TYPE OF VARIANCE: Allow an accessory structure (proposed approximately 1,288 square foot drive up ATM) to be located in front of the primary structure and within the front setback.

APPLICANT: JP Morgan Chase Bank

V-70

COMMENTS

PROPOSED SITE PLAN
 SCALE: 1" = 30'-0"
 PAGE 3

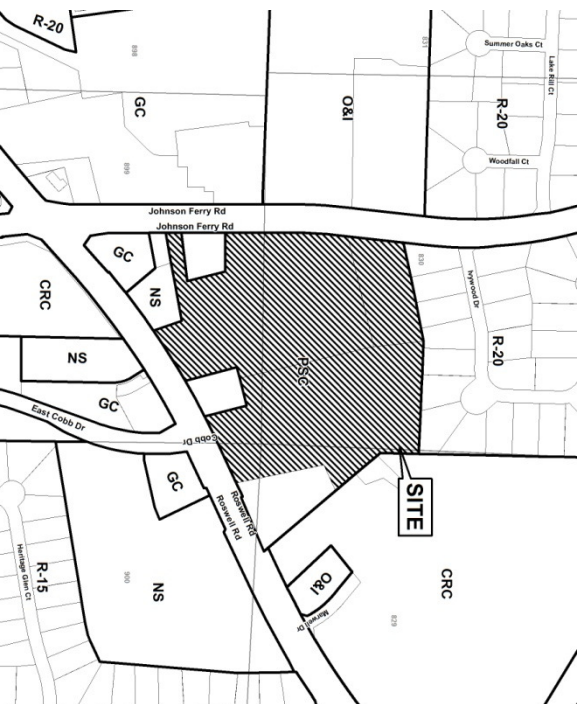
STORMWATER MANAGEMENT: The proposed ATM accessory structure will be located over existing asphalt paving. No adverse stormwater management impacts are anticipated.

SEWER: All permanent structures must be a minimum of 10 feet from the edge of the sanitary sewer easement.
